SEWAGE DISPOSAL SYSTEM MARYLAND STATE DEPARTMENT OF HEALTH*

HOWARD COUNTY
BUREAU OF ENVIRONMENTAL HEALTH
~~882-2330~~
461-9933

PROPERTY OWNER Timothy Rigler

PROPERTY ADDRESS: 1101 SHAFFERSVILLE ROAD, MT. AIRY, MD 21771

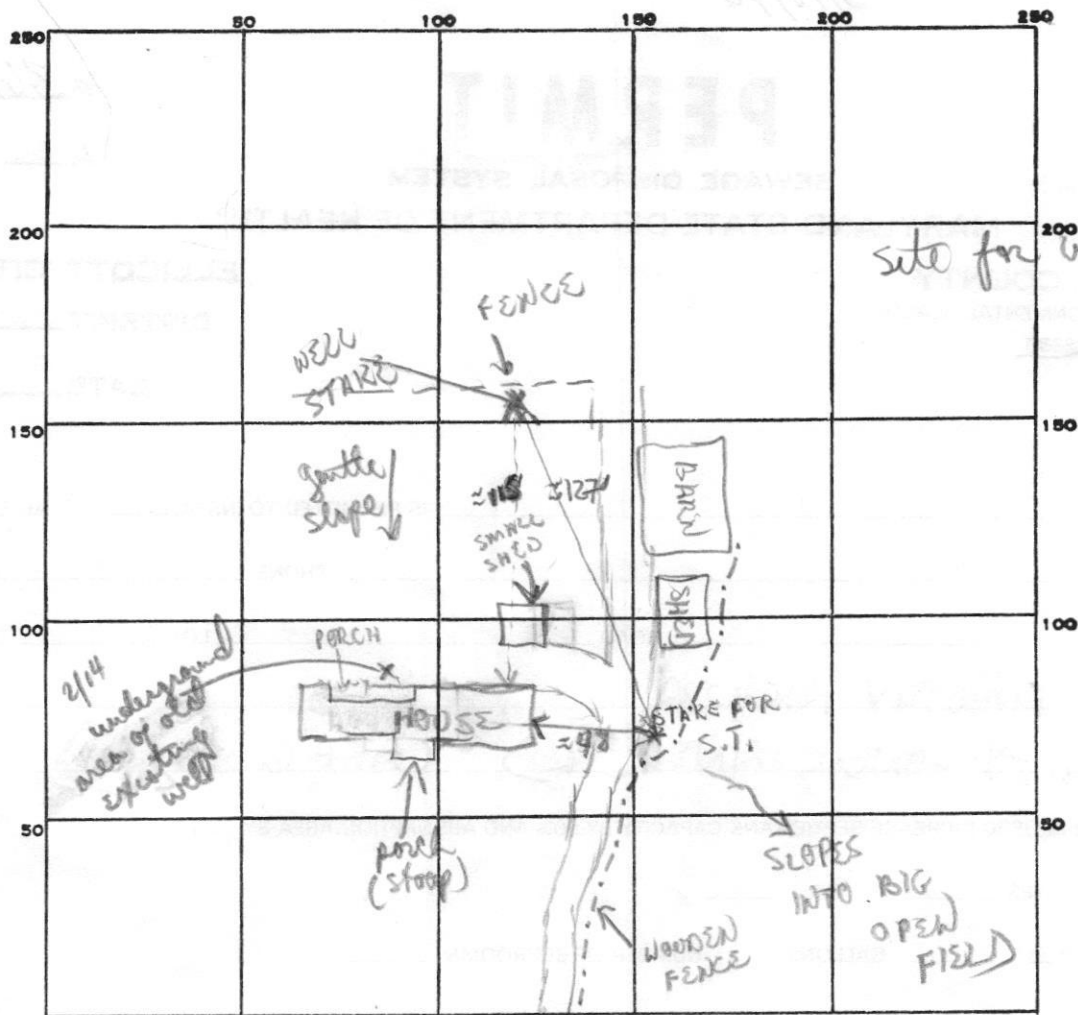
4/13/96 on reverse side a site drawing showing house, other buildings, S.T. + proposed replacement well site. old house - no previous records on file

REMARKS: No records on file. Old house. Drawing above is to establish locations of everything. Did not see original "hand dug" well. Replacement well site OK. Does not appear to be above ground C/O for S.T. where stake is located.

site for well OK'd
2/13/86
BA

HOUSE LOCATION SURVEY
 OF LANDS CONVEYED TO
TIMOTHY L. RIGLER
 AND
REGINA W. RIGLER
 LIBER 1435 FOLIO 601
 879 LONG CORNER ROAD
 FOURTH ELECTION DISTRICT
 HOWARD COUNTY, MARYLAND
 SCALE: 1" = 100' JAN., 1998

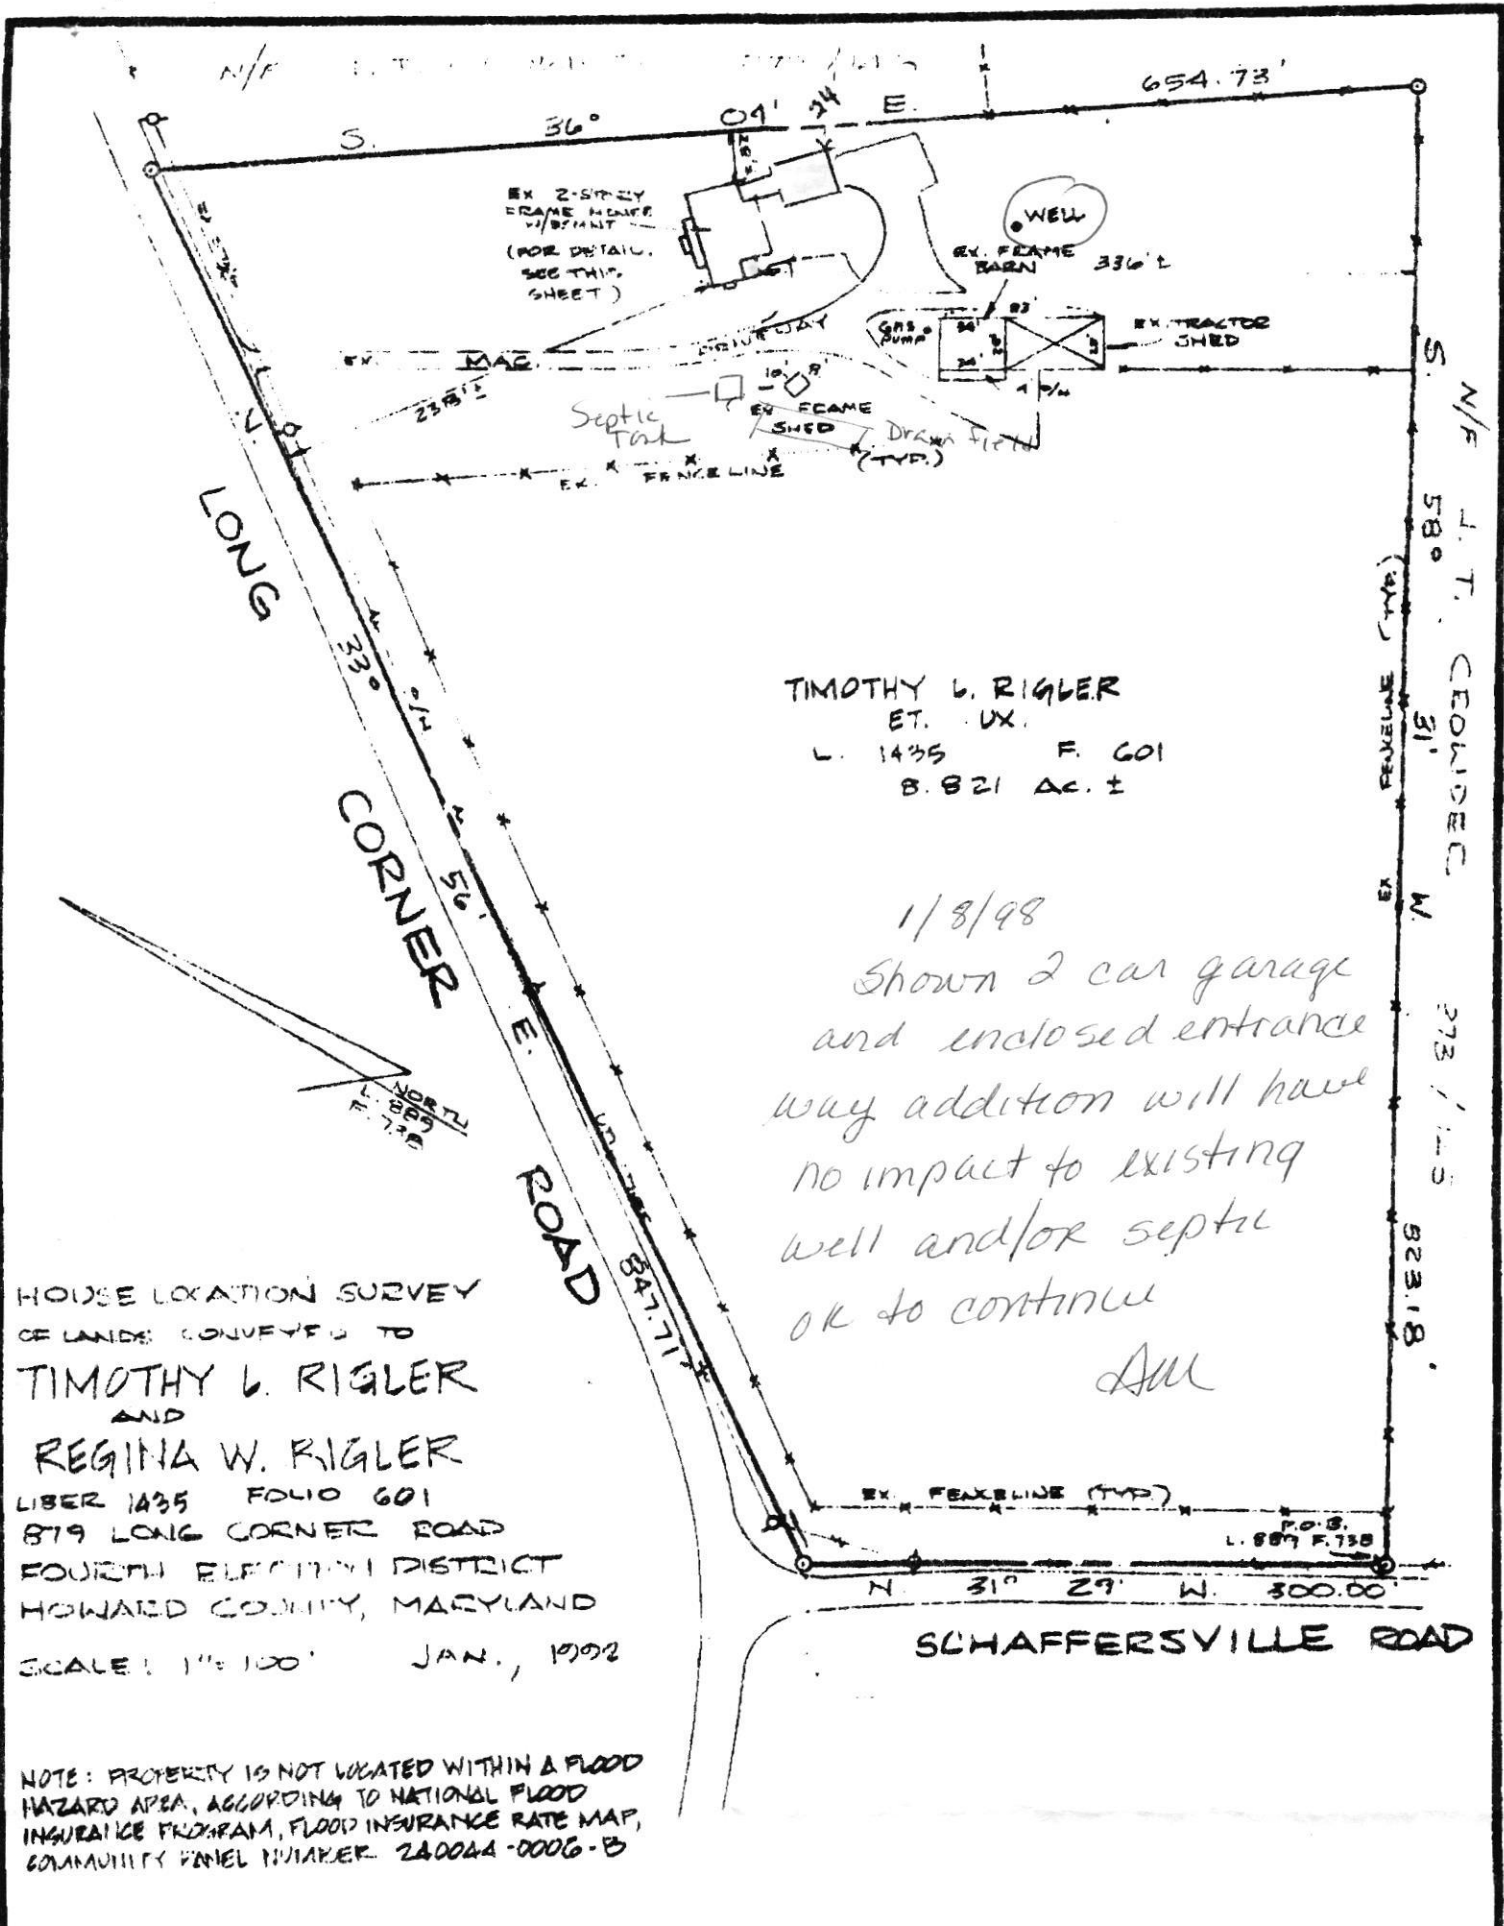
1/8/98
 Shown 2 car garage
 and enclosed entrance
 way addition will have
 no impact to existing
 well and/or septic
 ok to continue
 All

APPROVED 07/20/2022
 WALL CHECK DRAWING
 LOT 1
RIGLER PROPERTY

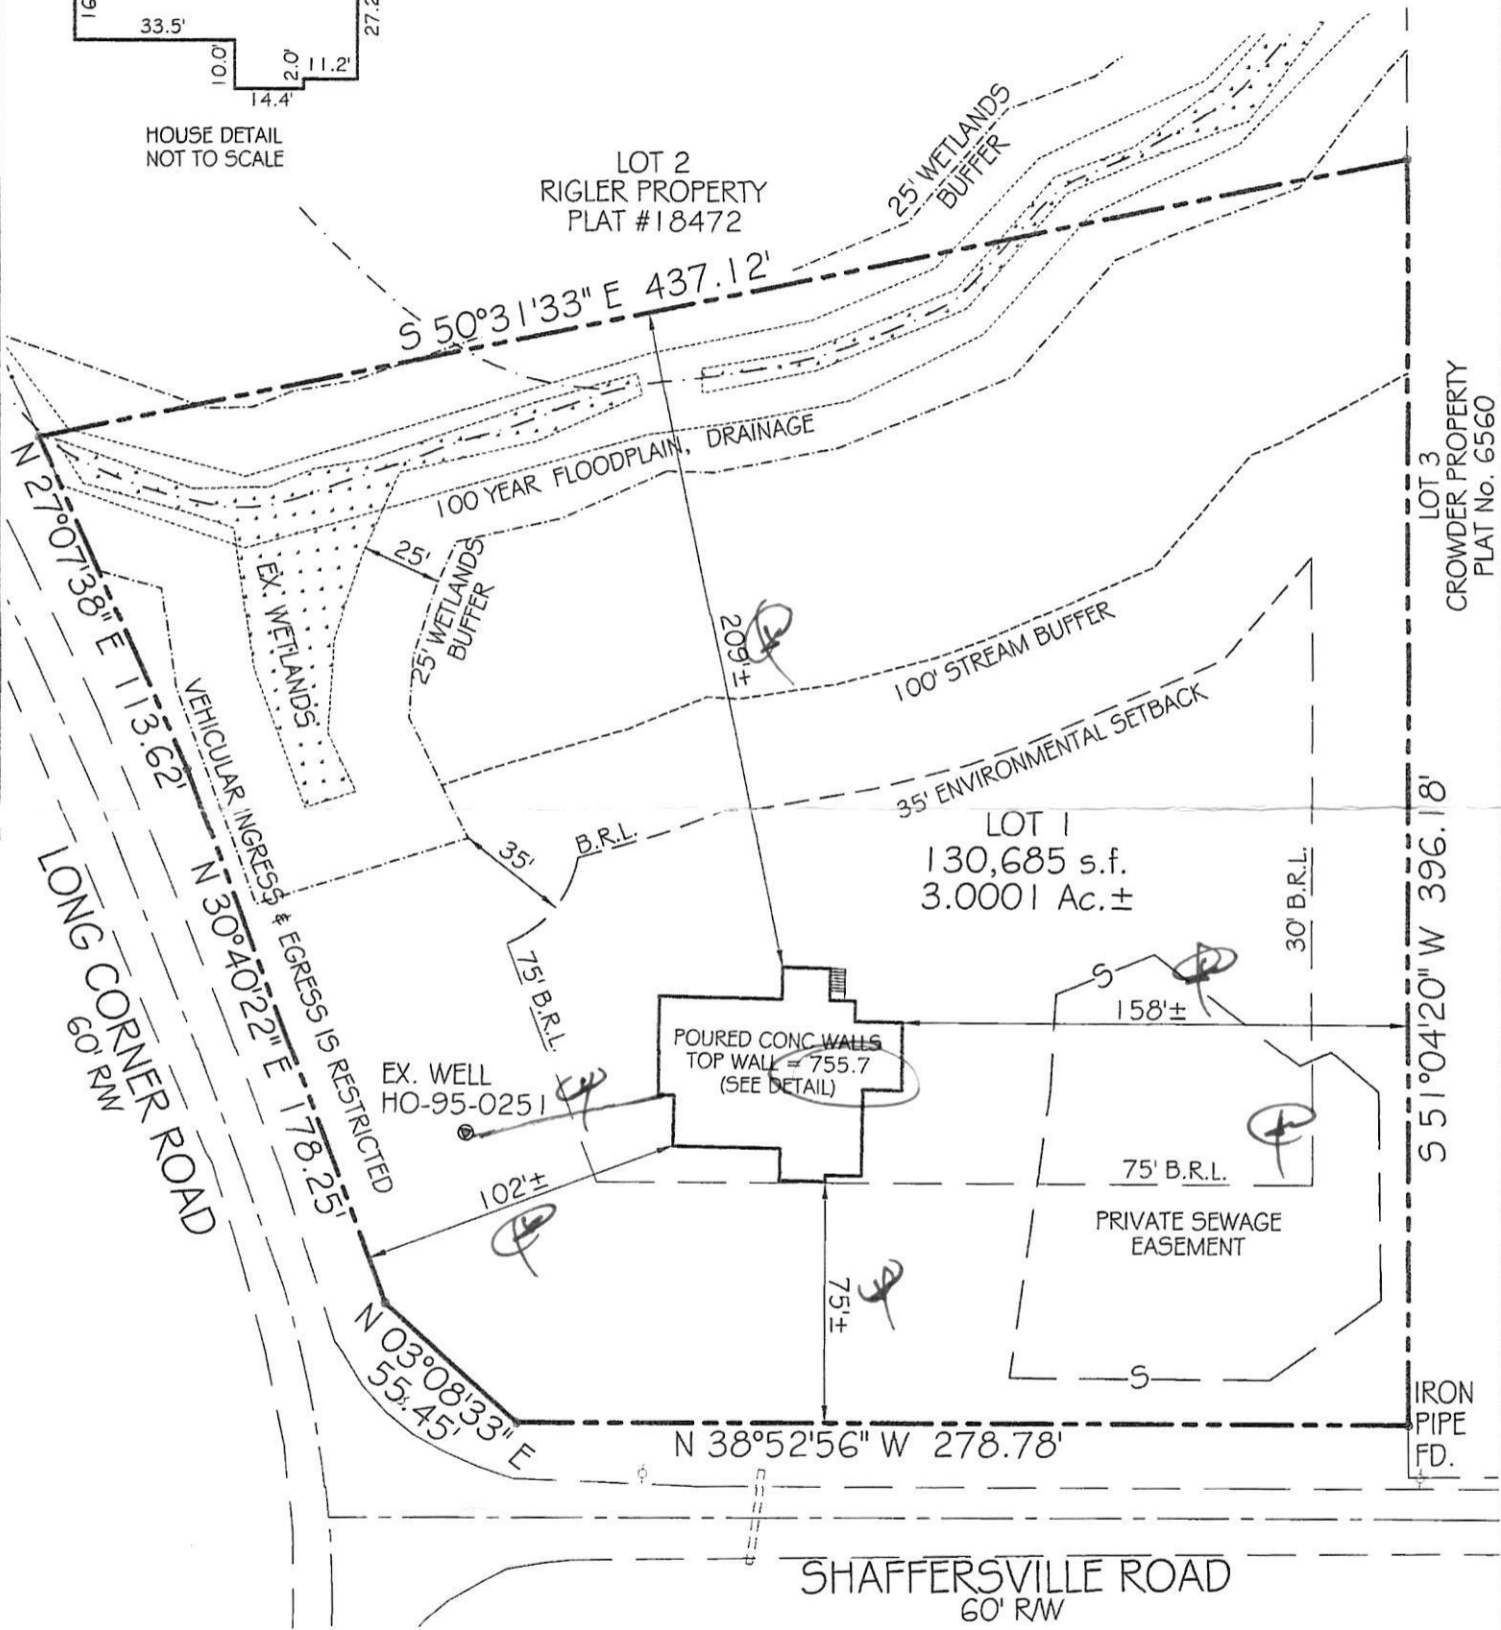
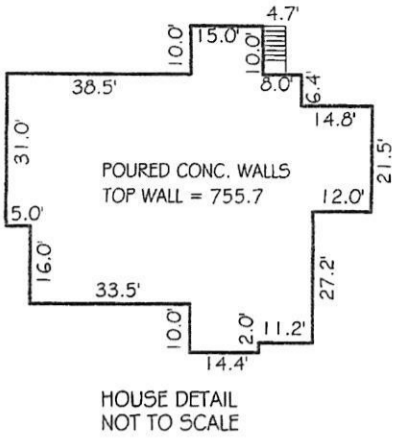
- Trenches must be located to provide room for 3 systems in the disposal area
All trenches must be equal length unless low pressure dosed
All trenches must be on contour
Tank and trenches must be placed as shallow as possible while maintaining 2% fall in pipe from house and at least 18" cover over trenches. If 2% fall from house is not possible, the minimum allowable fall is 1%.
Minimum trench spacing: 10' for all trenches utilizing sidewall reduction credit. Additional spacing may be necessary for any trench using over 3.5' of effective sidewall. In those cases, the spacing formula is 2D + W up to a maximum spacing of 18'.
Minimum trench spacing for trenches with no sidewall credit (bottom area only) is 6' for a 2' wide trench and 9' for a 3' wide trench (spacing is measured edge to edge)
Maximum trench length is 100'
Maximum pipe depth is 4'

★ BAT unit required
- only 2 systems OK
